Site Instruction

SI 10

PROJECT : Hampton Manor
PROJECT No : 1136.13
DATE : December 7, 2017

Title: Showing barrier-free symbol for barrier-free units

GROUND FLOOR PLAN
OVERALL PLAN

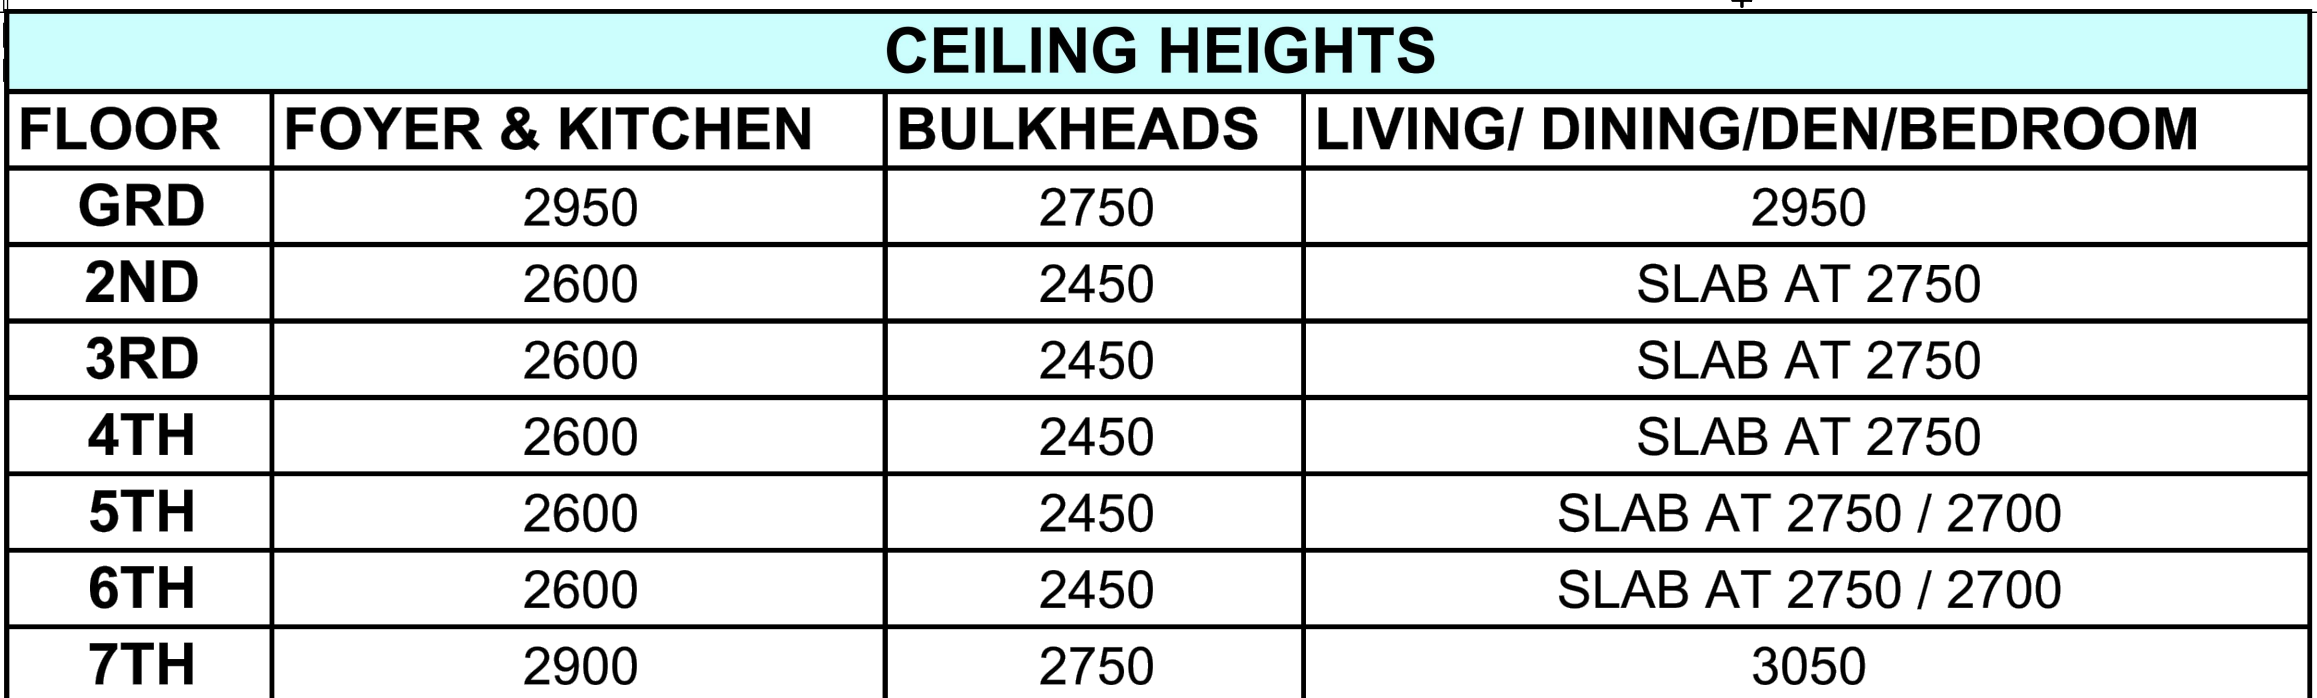
- Showing barrier free symbol for barrier free units.

**2nd FLOOR PLAN
OVERALL PLAN**

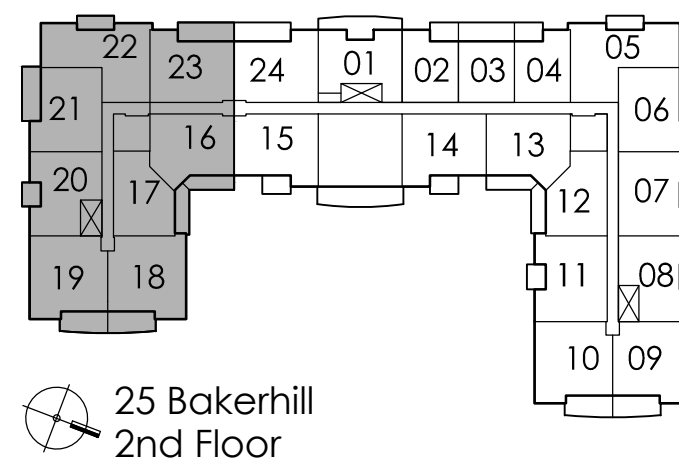
- Showing barrier free symbols for barrier free units.

3rd FLOOR PLAN

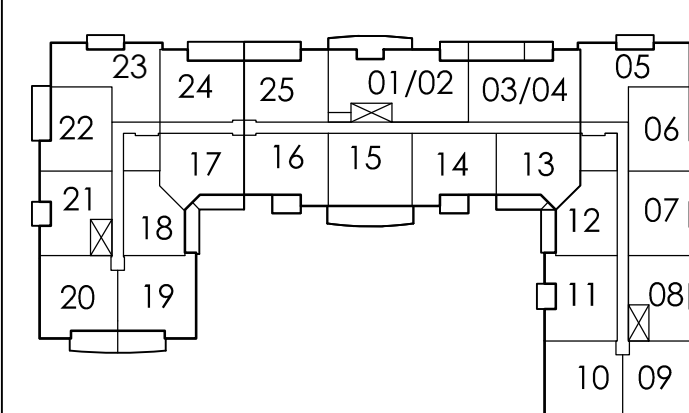
- Showing barrier free symbol for barrier free units.

4th FLOOR PLAN

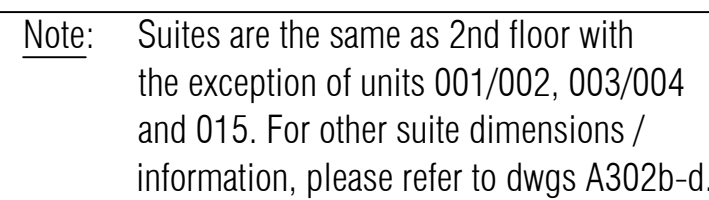
- Showing barrier free symbol for barrier free units.
